FIRE SAFETY INSPECTION REPORT

NAFISA APPARELS LIMITED

ACCORD ID: 11945

April 4, 2015

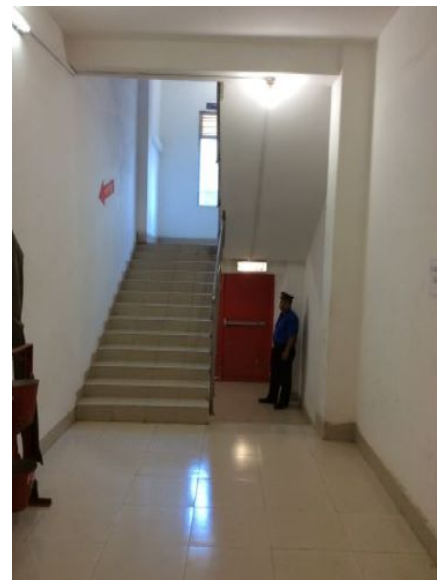
No.	Category	Finding	Recommendation	Remediation Timeframe
F-1	Fire Rated Construction	The exit stair enclosures are not separated from the ground floor by fire-rated construction.	The exit stair enclosure shall be provided with a minimum 2-hr fire resistance rating for buildings 4 or more stories.	Within 3 months

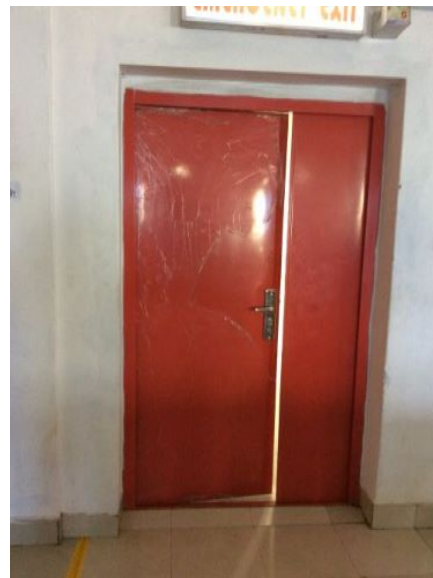
F-2	Fire Rated Construction	The fire-rated doors may not provide adequate separation from work areas and other spaces on each floor to the exit stairs.	Provide minimum 1.5-hr fire rated doors for buildings that are 4 or more stories. Seal all unprotected openings to separate the exit stairs from work areas and other building spaces on all floor levels. Ensure that the fire doors are self-closing and positive latching and that they are provided with fire exit (panic) hardware where serving production floors. If fire doors are required to be held open for functional reasons, provide automatic-closing devices tied to the fire alarm system. Once fire doors are installed, every door in a stair enclosure serving more than 5 stories shall be provided with re-entry unless it meets ACCORD standard 6.8.3.1.	Within 3 months
-----	-------------------------	---	---	-----------------

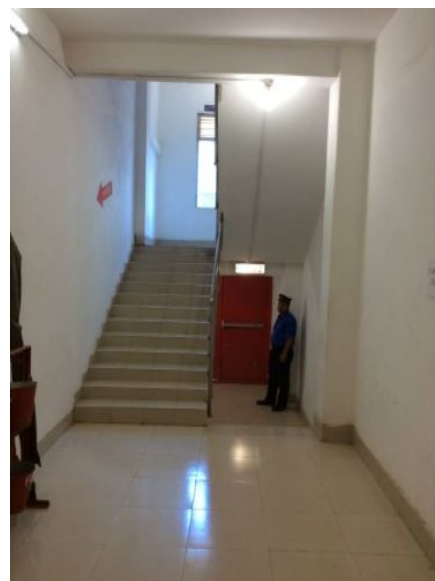
F-16	Egress	Handrails are not provided on both sides of all exit stairs.	Provide handrails on both sides of the exit stairs. New handrails shall have a minimum height of 865 mm (34 in.) and a maximum height of 965 mm (38 in.) as measured from the leading edge of the tread. Intermediate handrails shall be provided when the stair width exceeds 2.2 m (87 in.)	Within 3 months
------	--------	--	---	-----------------
